SUBJECT: RAPID RESPONSE TRANSMITTAL #08-070 Rev. A
Lower Control Arm (LCA) to Crossmember Mounting Bolts

INVOLVED VEHICLES:

2008 - 2009 (MK) Compass/Patriot

2008 - 2009 (PM) Caliber

Figure 1 – Lower Control Arm Crossmember Mounting Bolt

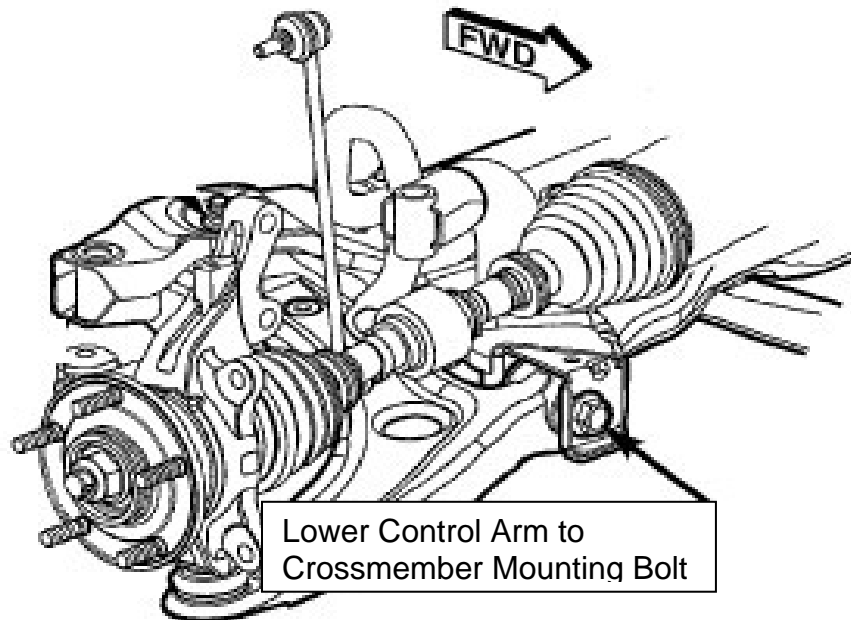
THIS IS A REVISION TO RAPID RESPONSE TRANSMITTAL #08-070 DATED SEPTEMBER 05, 2008 WHICH SHOULD BE REMOVED FROM YOUR FILES. THE REPAIR PROCEDURE CHECK TORQUE STEP HAS BEEN REMOVED AND DEALERS ARE REQUIRED TO REPLACE THE BOLTS. A NEW REPAIR PROCEDURE IS ADDED FOR SRT MODELS AND REQUIRES A NEW STYLE FLANGE BOLT, WASHER AND NEW TORQUE. ALL CHANGES ARE HIGHLIGHTED WITH **ASTERISKS.**

A number of vehicles may have been shipped with front lower control arm to crossmember mounting bolts that may not be tightened to proper specification. This can lead to a popping or snapping sound on bumps.

1. Place the vehicle on a suitable lift and raise vehicle high enough to service front lower control arm to crossmember mounting bolts.
2. Remove belly pan (if equipped).
3. ****Replace lower control arm to crossmember mounting bolts with new flange bolt p/n 06509096AA (Fig 1). ****
4. Torque new flange bolt to 150 Nm (111 ft. lbs.).
5. Install belly pan (if equipped).
6. Check front alignment and steering wheel centering.

1. Place the vehicle on a suitable lift and raise vehicle high enough to service front lower control arm to crossmember mounting bolts.
2. Remove belly pan (if equipped).
3. Replace lower control arm to crossmember mounting bolts with new flange bolt & washer p/n 06508844AA (Fig 1).
4. Torque new flange bolt & washer to 140 Nm (103 ft. lbs.).
5. Install belly pan (if equipped).
6. Check front alignment and steering wheel centering.
